M9019A-03

Information Only Service Note

M9019A PXIe Chassis: 18-slot, 3U, 24 GB/s, Gen 3

Code 10 errors under Device Manager for PCI Express to PCI/PCI-X Bridge when use with M9025A.

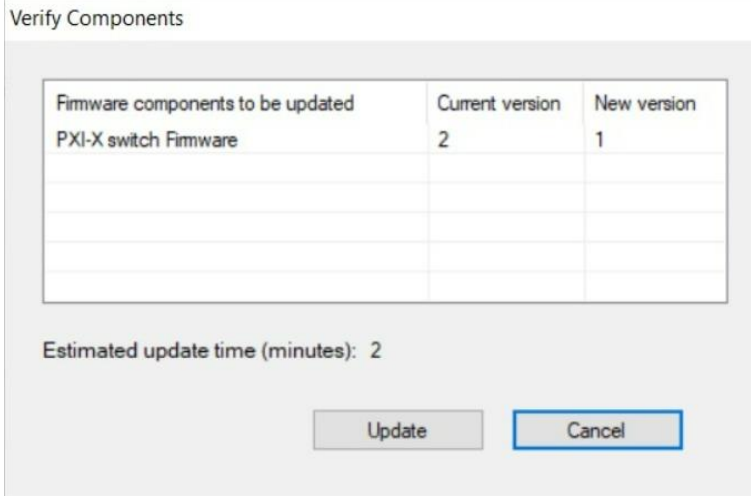
It has been found when the affected chassis are used with M9025A PXIe Thunderbolt System Module that the Device Manager would encounter code 10 errors under the PCI Express to PCI/PCI-X Bridge like picture below.

Follow the steps below to resolve the code 10 errors at the PCI Express to PCI/PCI-X Bridges.
